Questions from the Committee

1) Dead/Noisy Channel History at MicroBooNE

1) Dead/Noisy Channels

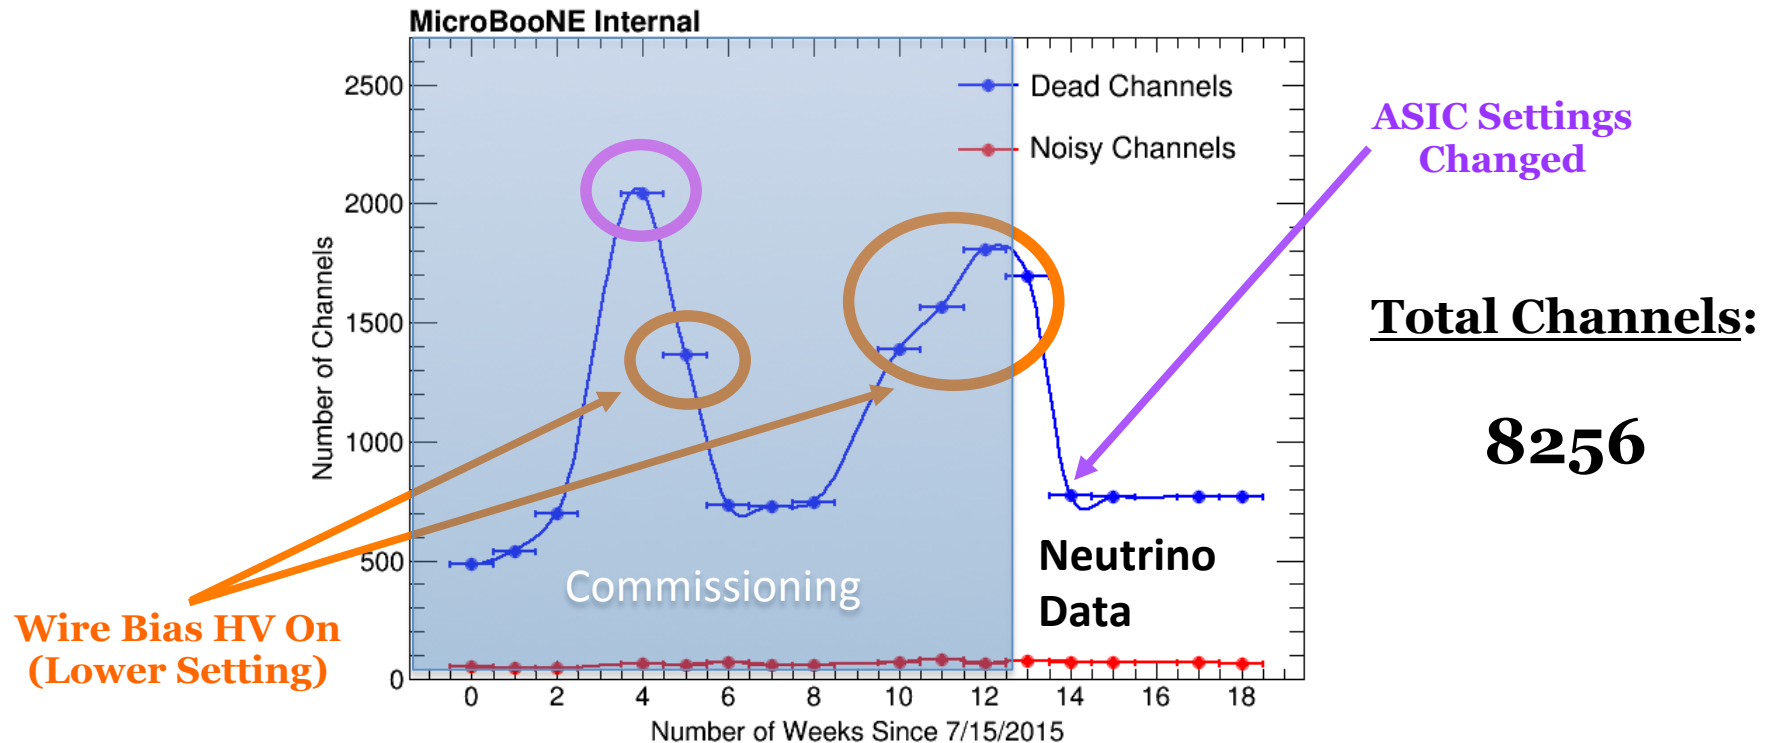
- 1) Are you still losing channels? Can you provide data that supports your conclusions (e.g. no. of non-responsive channels vs. time)?
- 2) Can you please spell-out for us your run plan, highest priority analyses, studies required, reprocessing plans, intermediate milestones, etc for 2016? (*split into 3 for operations/technical coordination, physics analysis, analysis tools*)
- 3) Performance metrics and specifications for a) high priority analyses in 2016 and b) low E excess analysis.
- 4) Which analyses would be impacted by using a PE threshold significantly larger than originally planned?
- 5) What do you most need from the lab or collaboration?
- 6) In the table of spare parts provided in the EOP, can you please add a column that specifies the number of units required for the experiment?

- ◆ Shown are **dead** (long-term **and** transient) and **noisy** channels
- ◆ Most dead channels transient, fixed with change in ASIC settings
- ◆ Non-transient channels **stable** since wire bias HV settings lowered

Question 4

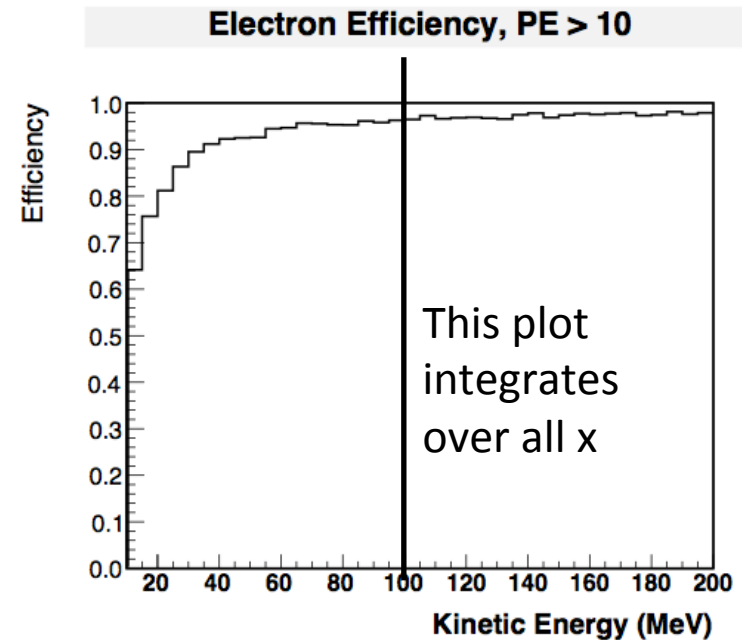
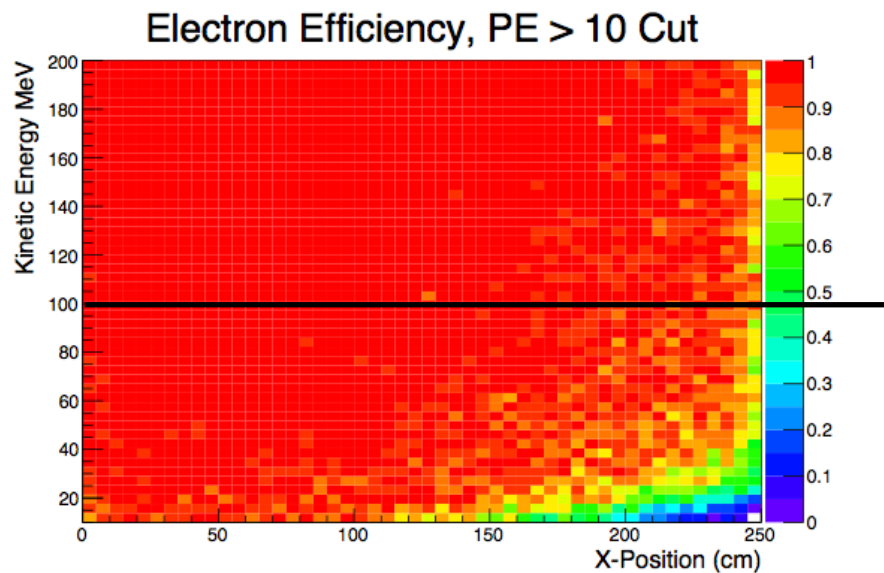
- Which analyses would be impacted by a PE threshold significantly higher than originally planned?

- The TDR aimed for a >2 pe threshold
- We will look at the effect of a >10 pe cut, which reduces the fraction of BNB spills accepted to $<5\%$
- Note that we plan to be doing everything in our power to understand and reduce the background light rate
 - e.g. remove large fraction of filter material to reduce emanation rate

- List of some analyses and an estimate of their energy ranges
 - **Low energy excess:** ~140 MeV electrons from 200 MeV neutrinos + some proton energies
 - At >10 PE should be fully efficient across detector for most of the electron energy range
